**YANKEE ATOMIC ELECTRIC COMPANY**

September 14, 1973

Reference: License No. DPR-3 (Docket No. 50-29)

PROPOSED CHANGE: Reference is made to the description of the Emergency Core Cooling System in Yankee Atomic Electric Company Change number 97 and in particular to the description of the initiating circuitry in Attachment B of Supplement #3, Change #97. We propose the following: To provide vapor container overpressure signals to the WL relays in parallel with the existing main coolant pressure and pressurizer pressure signals in order to provide a diverse method of emergency core cooling system initiation.

Open & Closed Bulb Piping Before Change

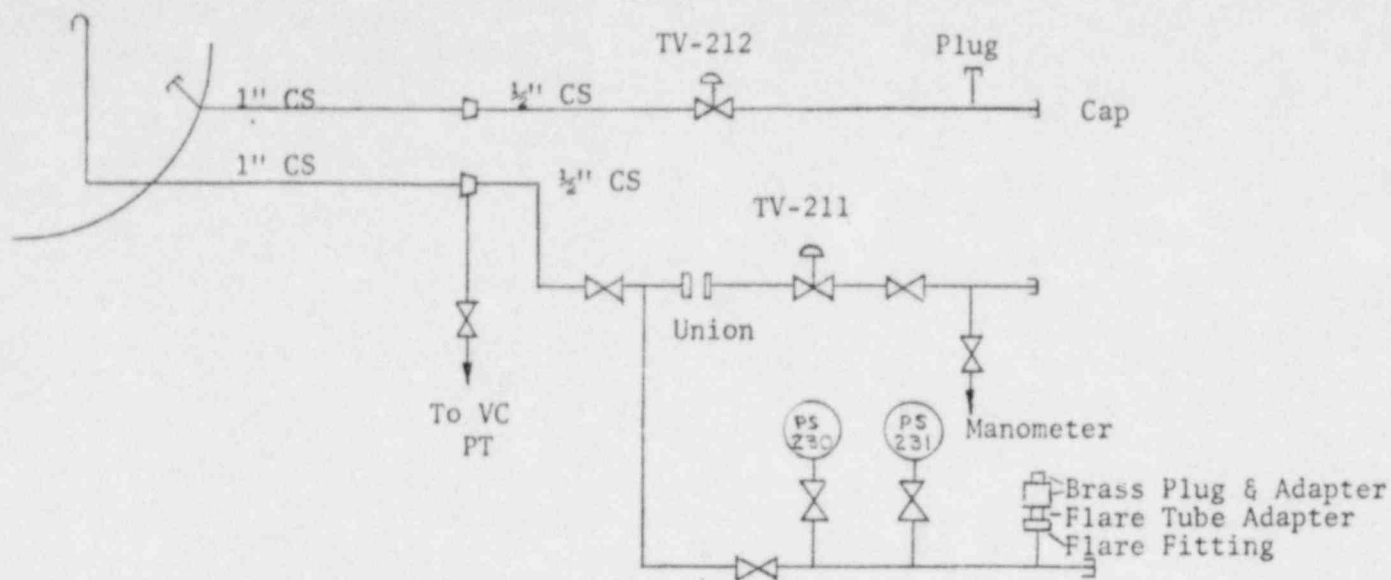
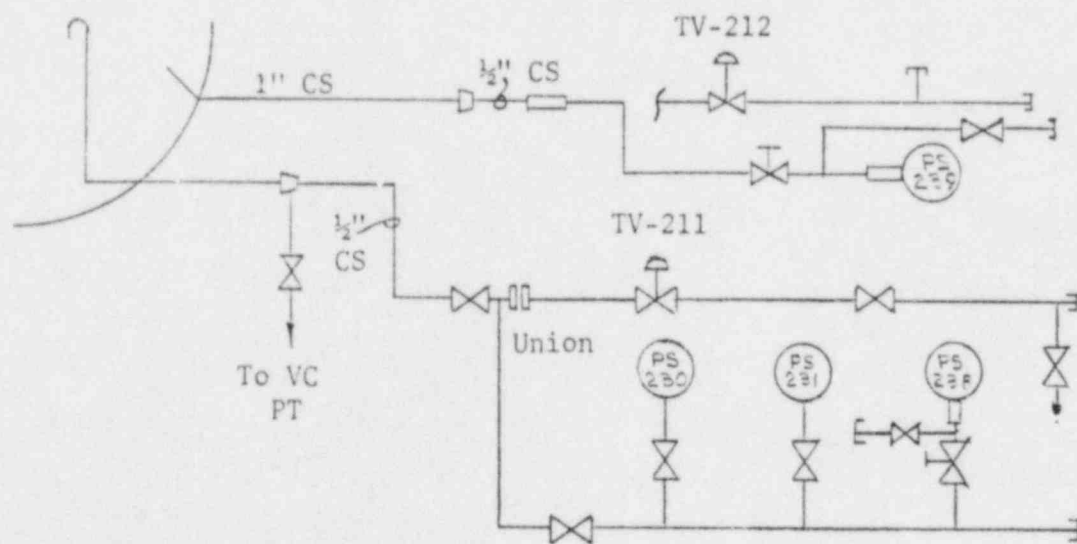
DESCRIPTION OF CHANGE: Diverse initiation of the emergency core cooling system will be accomplished by providing vapor container overpressure signals to the WL relays in parallel with the existing main coolant and pressurizer pressure signals. Two pressure switches will be mounted in the primary auxiliary building. One switch, designated PS-238, will sense the vapor container pressure via the open bulb system and be electrically connected to trip WL 1-1. The other pressure switch, designated PS-239, will use the vapor container closed bulb system piping to sense vapor container over pressure and will be electrically connected to trip WL-1. The closed bulb system will be vented to the vapor container pressure. Use of the closed bulb system
